COAL ASH IMPOUNDMENT SITE ASSESSMENT REPORT

**Coffeen Power Station
Ameren Energy Generating Company
Coffeen, Illinois**

KLEINFELDER PROJECT NUMBER 112618-3

April 2011

TYPICAL EMBANKMENT SECTION - RECYCLE POND

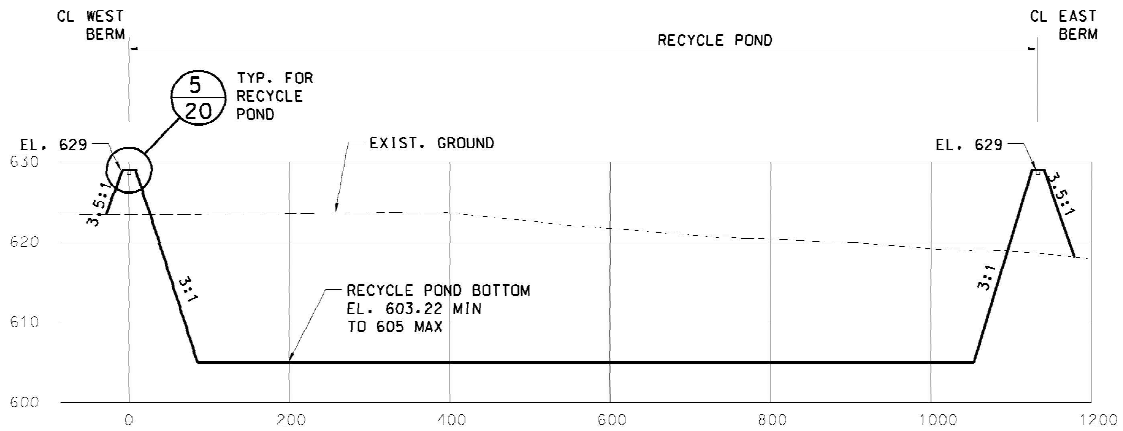
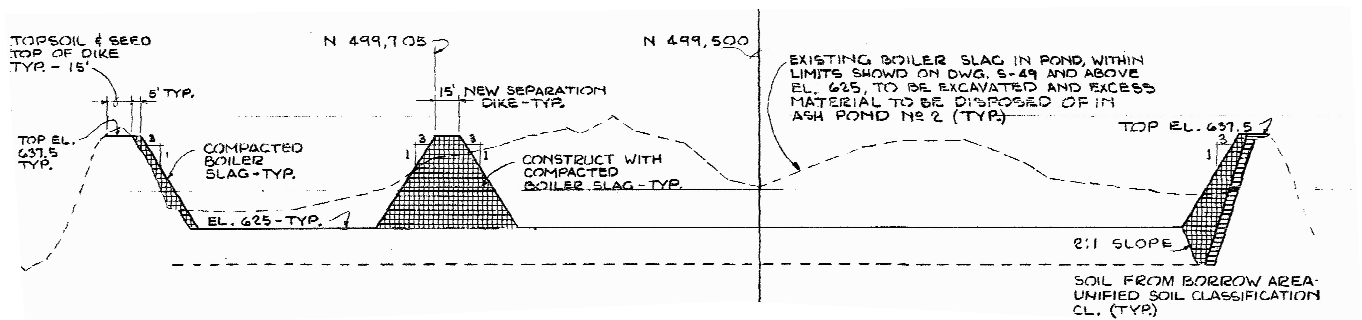
- The upstream slope was laid back at approximately 1.5H:1V, based on visual observations. This varies from the construction documents provided by Ameren, probably due to the build-up of bottom ash on the embankment. However, it is possible that cleanout operations at the Recycle Pond could have cut into the embankment and steepened it over time.
- Minor erosion rills, less than 6 inches deep, were noted on some of the upstream slopes.
- Grasses and woody bushes were observed on the upstream slope for the majority of the south and east embankments of the impoundment.
- Mowing/Vegetation control had not been completed on the majority of the upstream slope.
